From: tony.cooley@ky.gov
Sent: Friday, June 10, 2011 2:22 PM
To: George.Gilbert@ky.gov; Sharon.Gritton@ky.gov; Wilson.Tan@ky.gov; shawn.cecil@ky.gov; robert.daniell@ky.gov; ron.gruzesky@ky.gov; Jon.Maybriar@ky.gov; April.Webb@ky.gov; bob.bickner@ky.gov
Cc: Tammi.Hudson@ky.gov
Subject: RE: Jefferson Co. Bridges
Attachments: Page 56 Section 4.pdf; Section 4 crosses lagoon.pdf; Page 50 overview map.pdf

Section 4

The Bridges Project

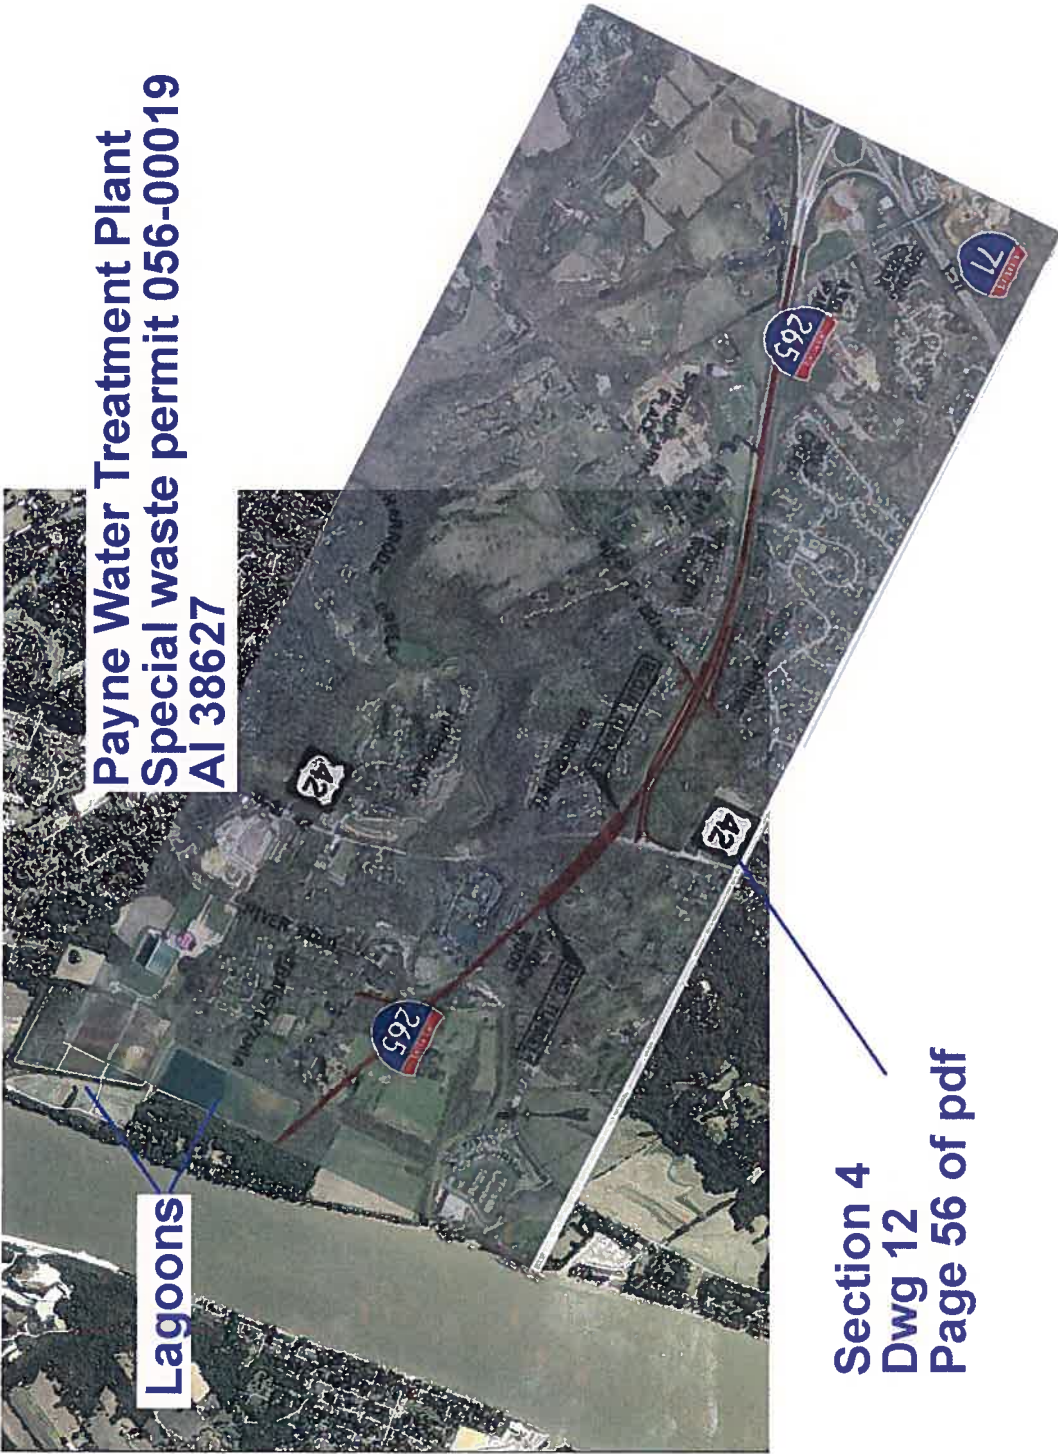
The proposed route for Section 4 of the new bridge plan appears to cross part of one of the sedimentation lagoons at the Payne Water Treatment Plant, AI 38627. These lagoons contain sediment settled from filter backwash water and are included as part of a beneficial reuse under SW 056-00019. I have asked Bob Bickner to add further comments as he is familiar with this site and permit.

Section 4
Dwg 12
Page 56 of pdf

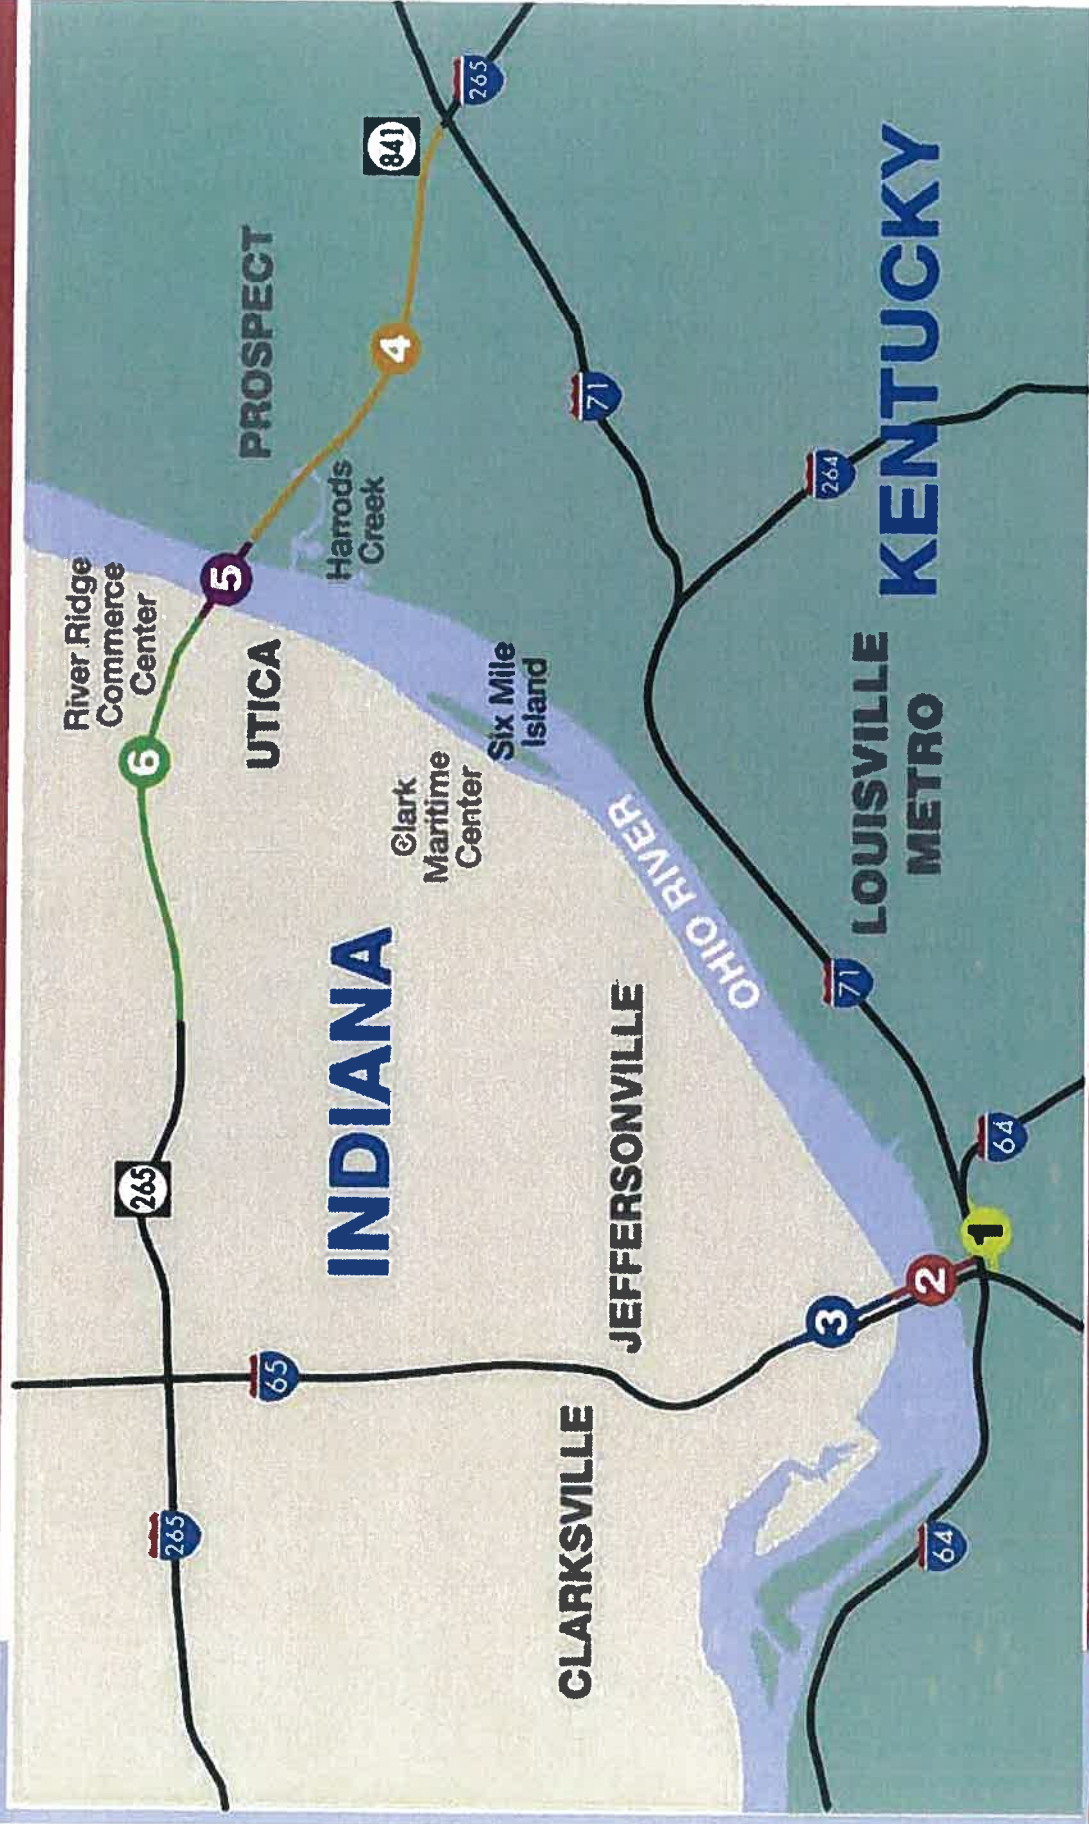
Payne Water Treatment Plant
Louisville Water Company
AI: 38627
Special Waste Permit
active
SW 059-00019

Section 4

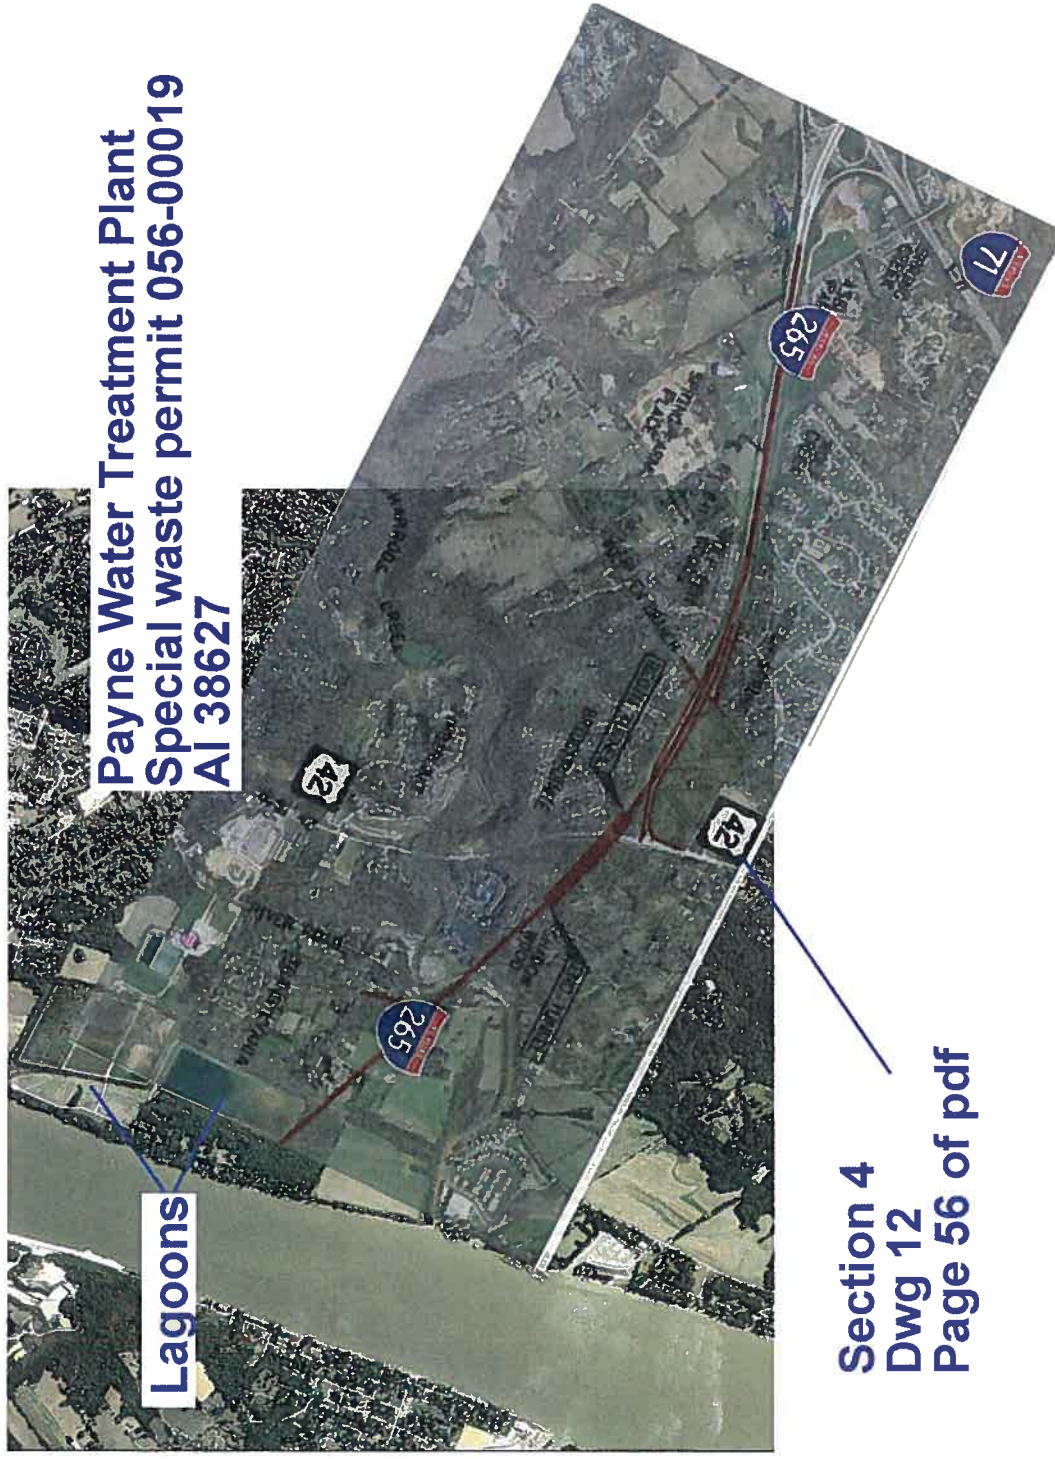
The proposed route for Section 4 of the new bridge plan appears to cross part of one of the sedimentation lagoons at the Payne Water Treatment Plant, AI 38627. These lagoons contain sediment settled from filter backwash water and are included as part of a beneficial reuse under SW 056-00019. I have asked Bob Bickner to add further comments as he is familiar with this site and permit.

Section 4
Dwg 12
Page 56 of pdf

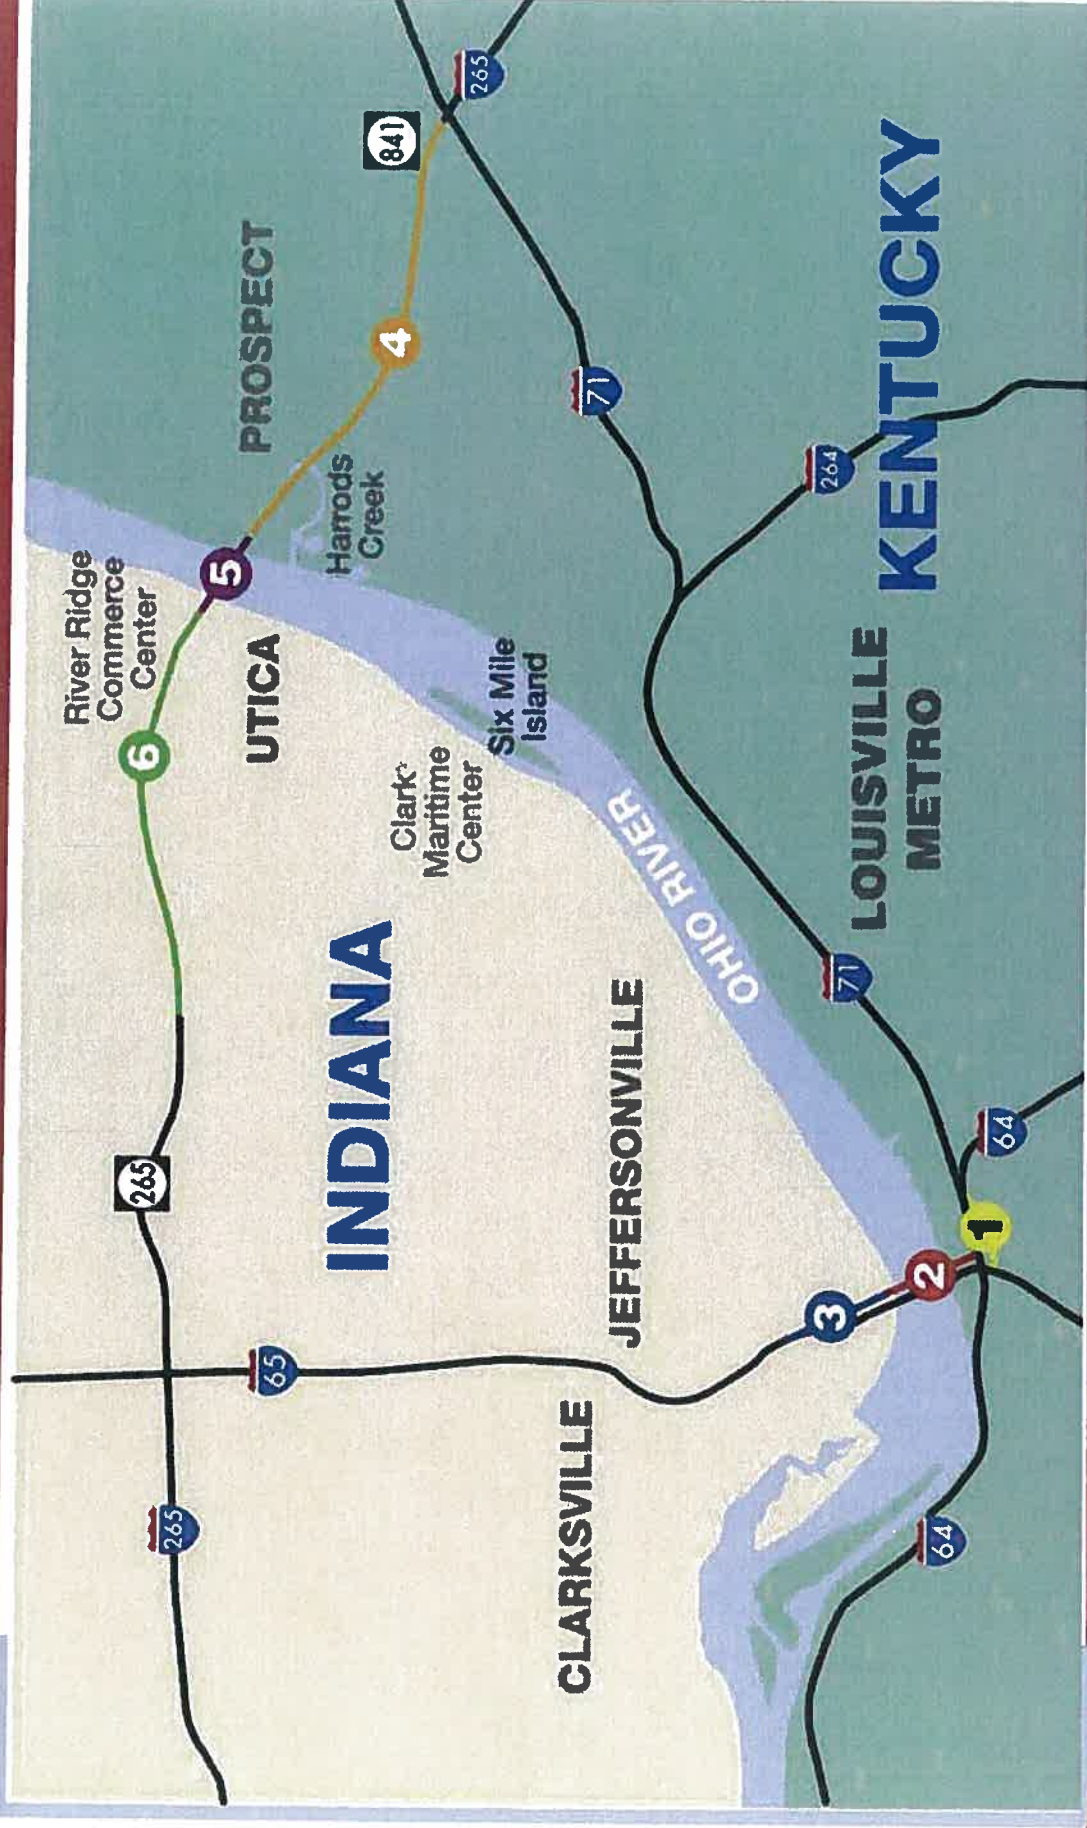
Payne Water Treatment Plant
Louisville Water Company
AI: 38627
Special Waste Permit
active
SW 059-00019
